Liberty Knitwear Ltd. Unit-2 (Extension)

27th May & 3rd June 2018

Observations

Observation: Printing tower building

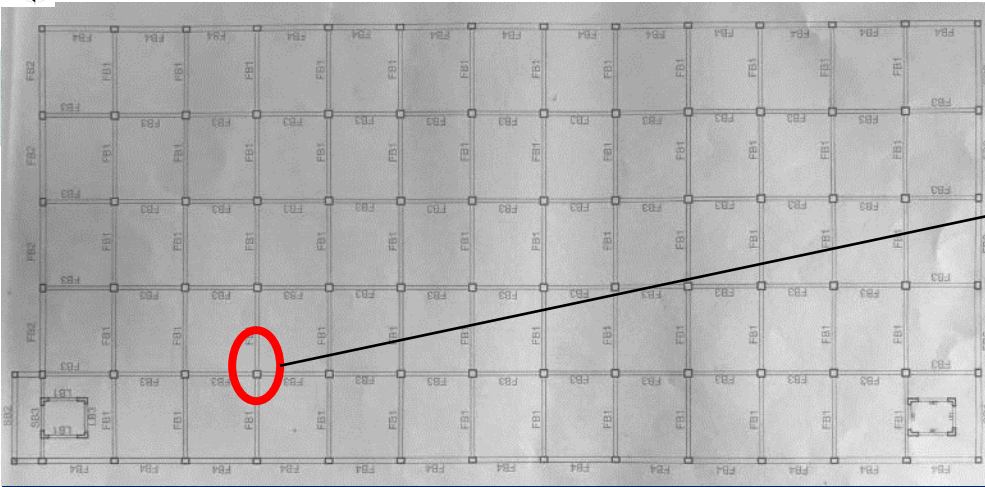
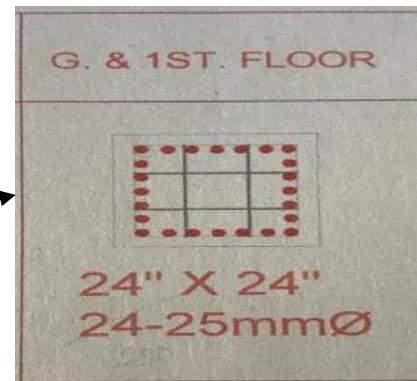
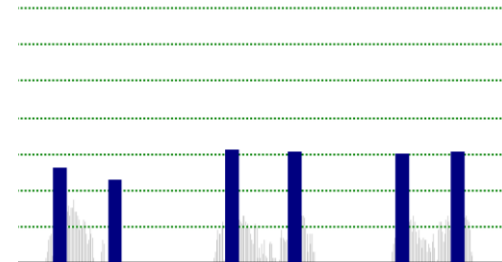
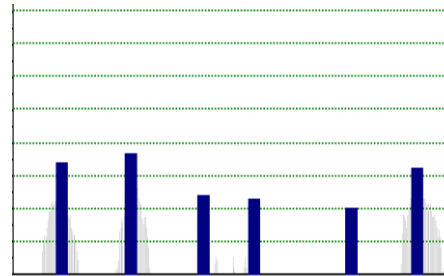
**Columns appeared to be stressed in excess
of normal design limits**

Cursory calculation indicates that highlighted columns appear to be stressed above normal design limits due to large grid dimension and less reinforcement found from ferro scanning compared with that of column schedule. Factory engineer needs to check column stress and factory should take necessary action according to report.

6 **Observation: Printing tower building**

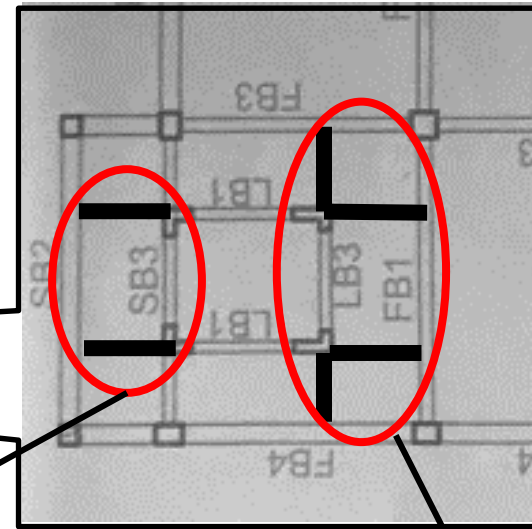
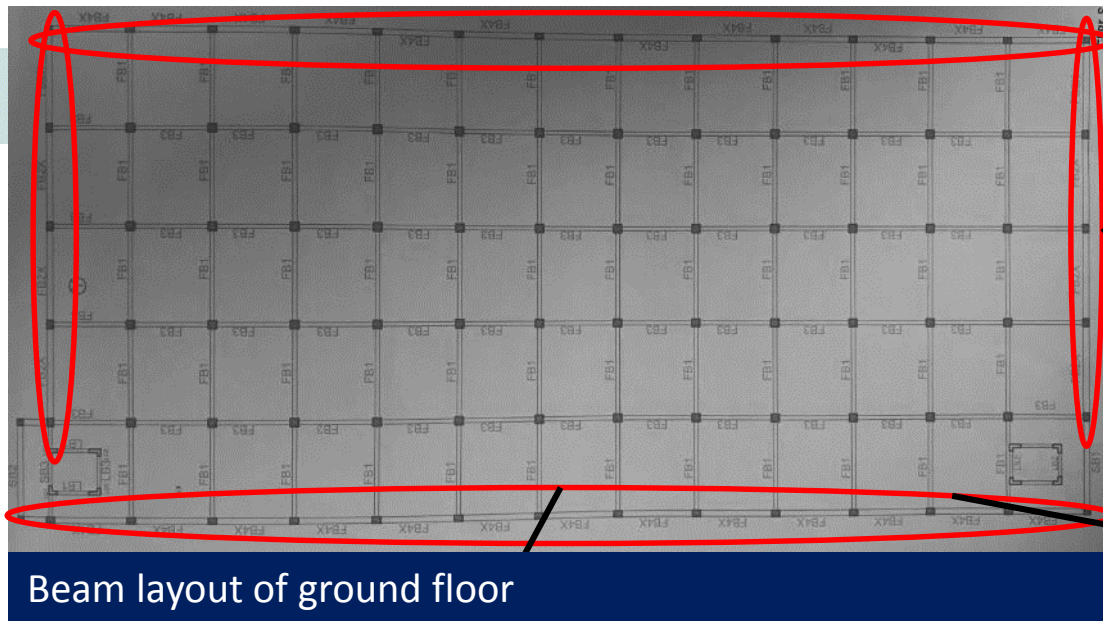
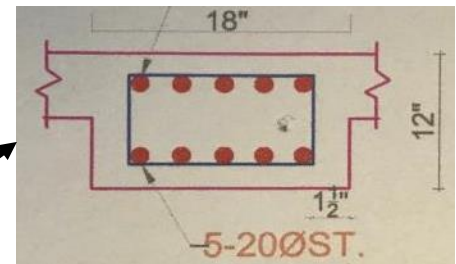
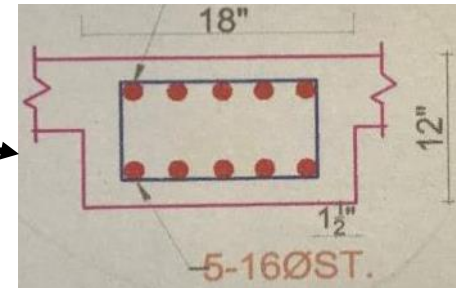
Discrepancies between as-built drawings and on-site observation

Some extra beams were found in the stair case in every floor which were not in as-build drawing.

Inverted beam was found on west side

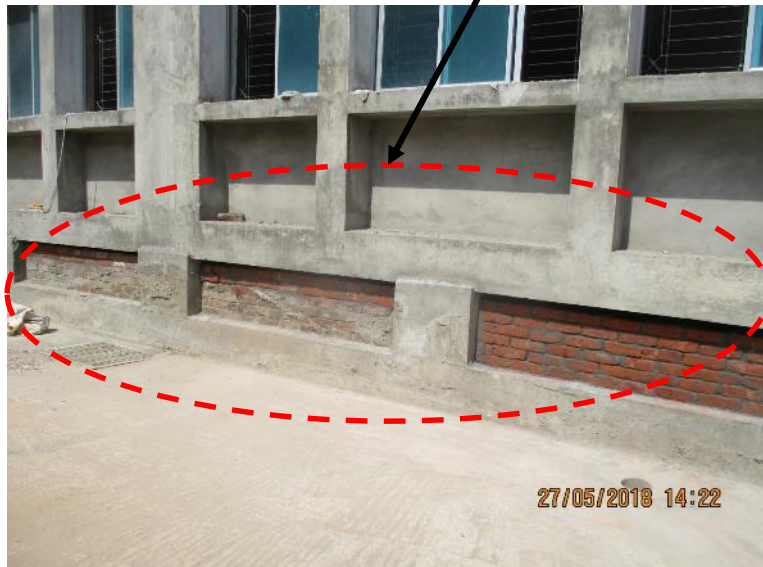
Inverted beams were observed on all side of the building at ground floor level. But in the as-built drawing's beam schedule, the beams were not shown as inverted beams. Factory is required to update the as-build drawing.

Dampness observed on Basement wall

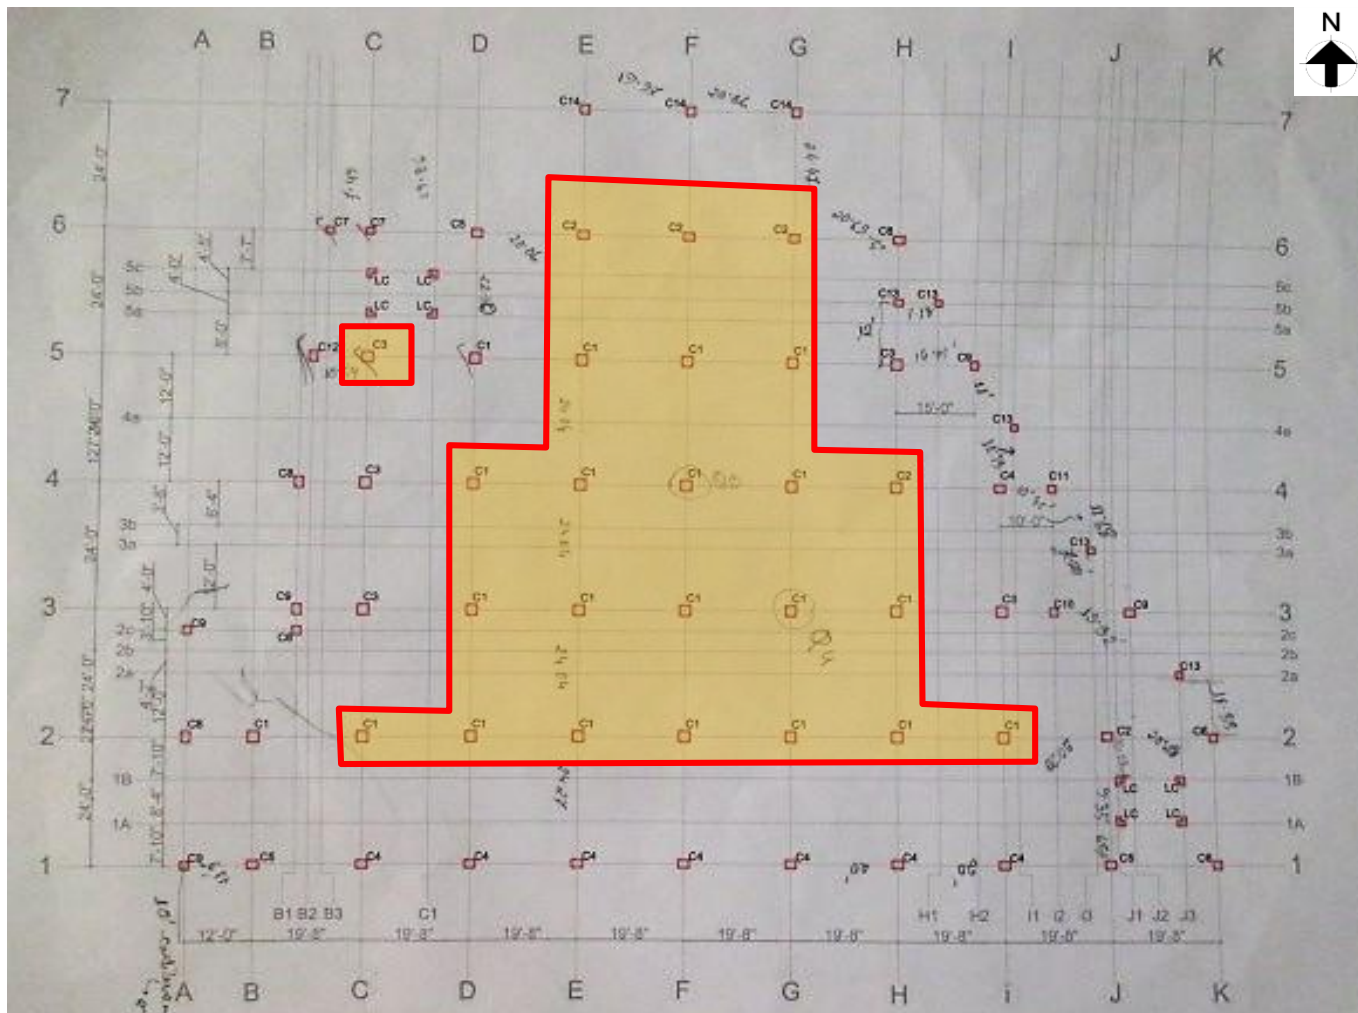
Dampness observed on several places in the basement wall. Factory Engineer is required to investigate the extent of dampness and suggest necessary remedial action.

Observation : New Admin Building

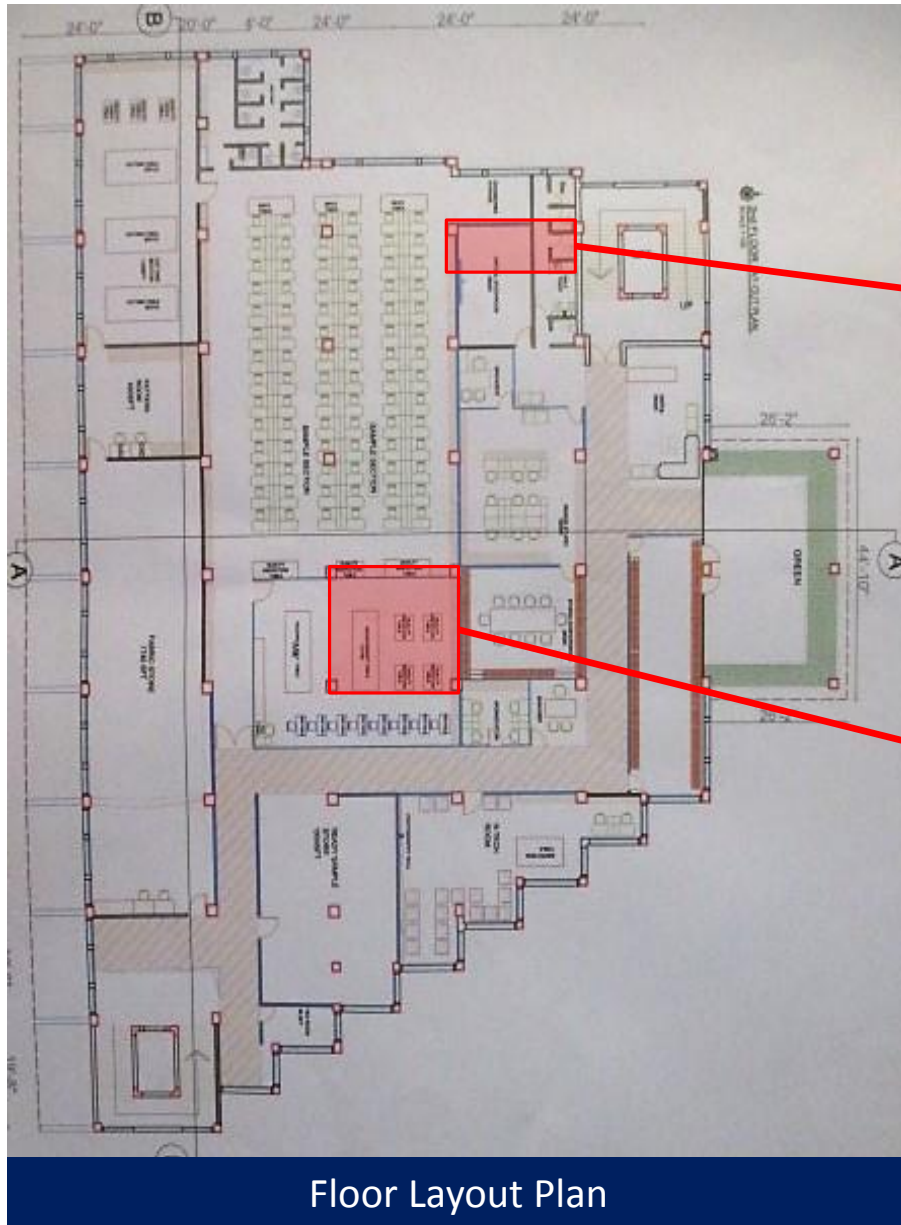
Cursory calculation indicates that highlighted foundations appear to be stressed above normal design limits. Factory engineer needs to check foundation stress and a Detail Engineering Assessment (DEA) must be carried out and factory should take necessary action according to report.

Water clogging and lack of drainage system on roof

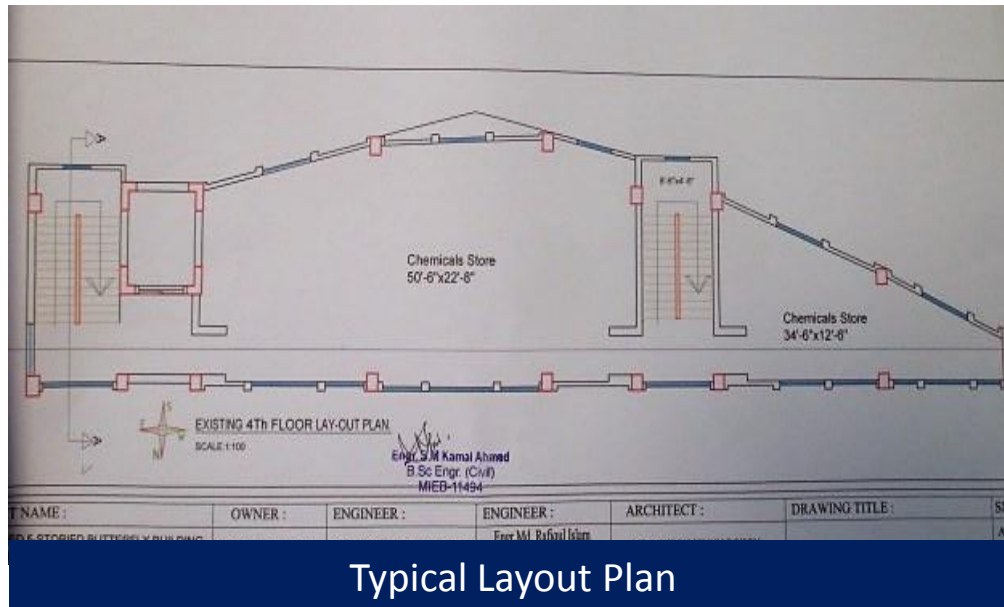
Water clogging was observed on roof top which indicates poor drainage system. Factory engineer is required to provide water proofing material with appropriate sloping and improve drainage system.

Typical Layout Plan

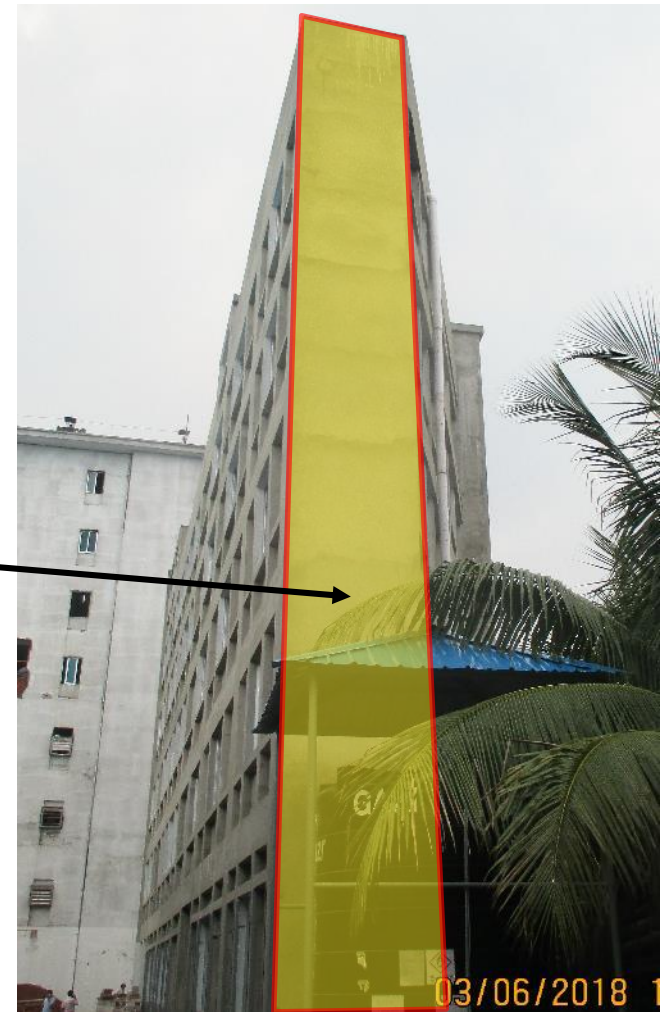
Apparent lack of lateral stability

Factory engineer to check lateral stability of the building against lateral load combination for poor aspect ratio. The structural arrangement in tall slender building may result in net tension in structural element.

Water clogging and lack of drainage system on roof

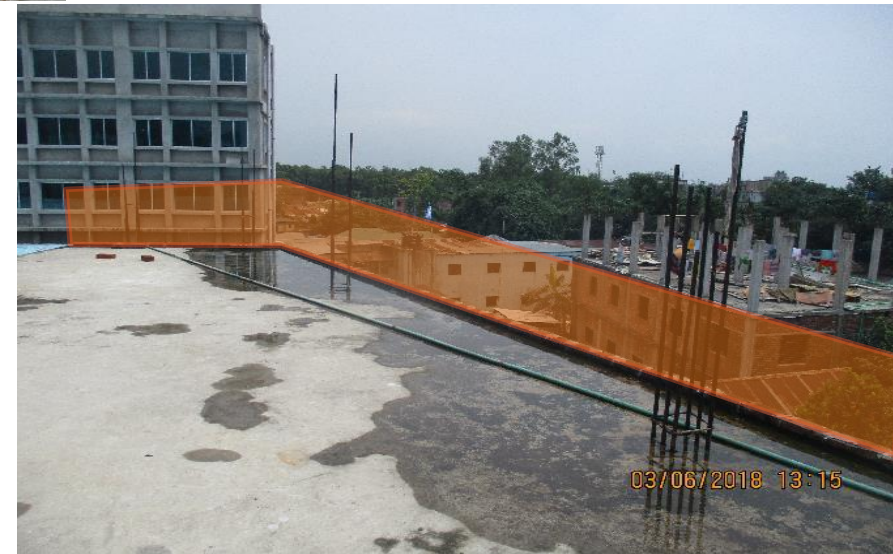
Water clogging was observed on roof top which indicates poor drainage system. Building engineer is required to provide water proofing material on the roof top with appropriate sloping and improve drainage system to prevent water ponding.
